CITY OF PORTLAND, MAINE

Seashore Ave.; Peaks Island

Your application to construct a single family dwelling has been reviewed and a permit is herewith issued subject to the following requirements:

BUILDING PERMIT REPORT

SUBSURFACE WASTEWATER DISPOSAL PLAN

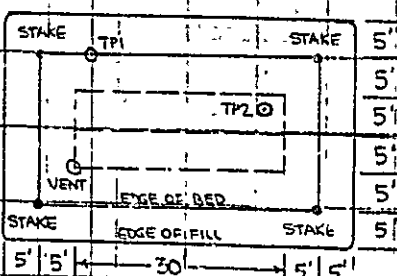
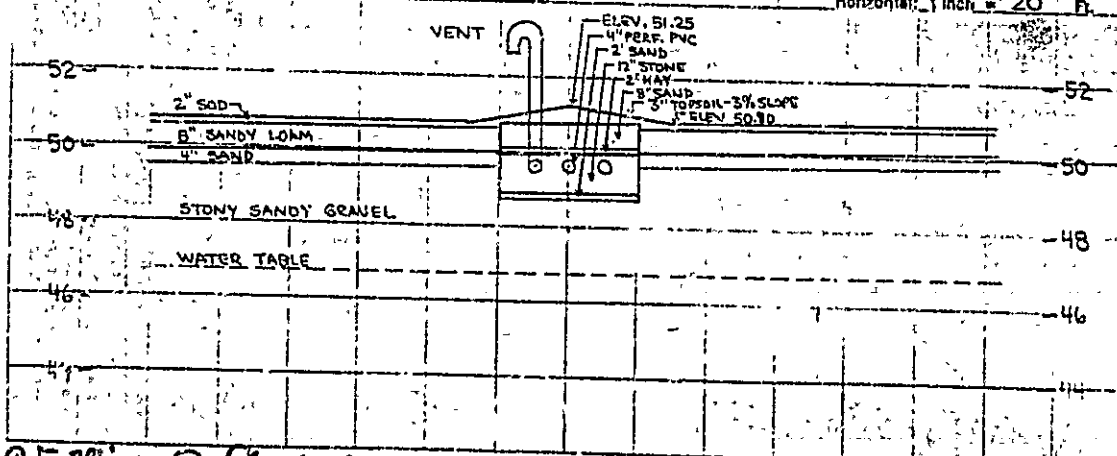
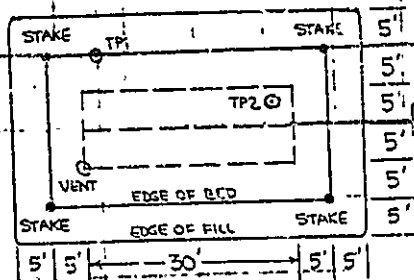
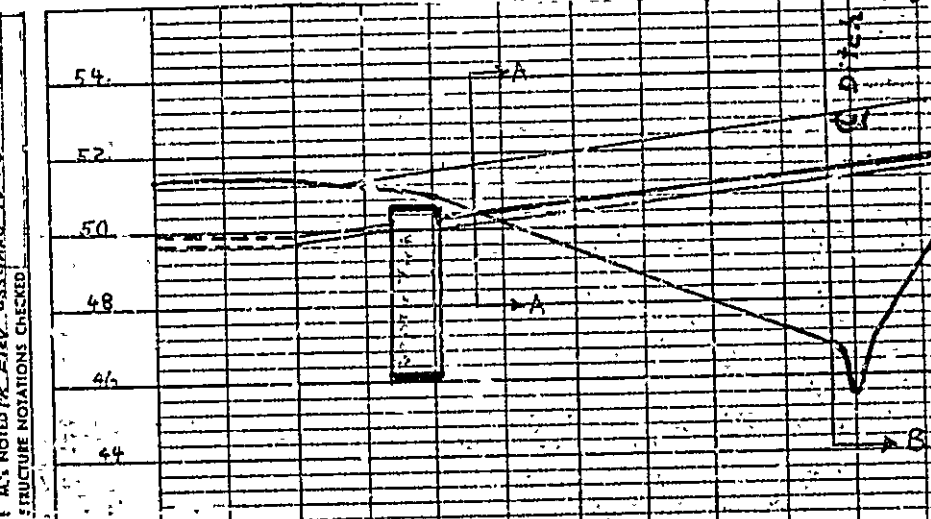
We have been advised by the City Plumbing Inspector, Mr. Ernold Goodwin, that the Forms HHE-200 Soils Test Analysis Results for inground septic disposal must be updated before a building permit can be issued for your proposed building. The State Plumbing Code has changed since 1984 and therefore a new site evaluation by the site evaluator, or a check by the original site evaluator must be made to update this report.
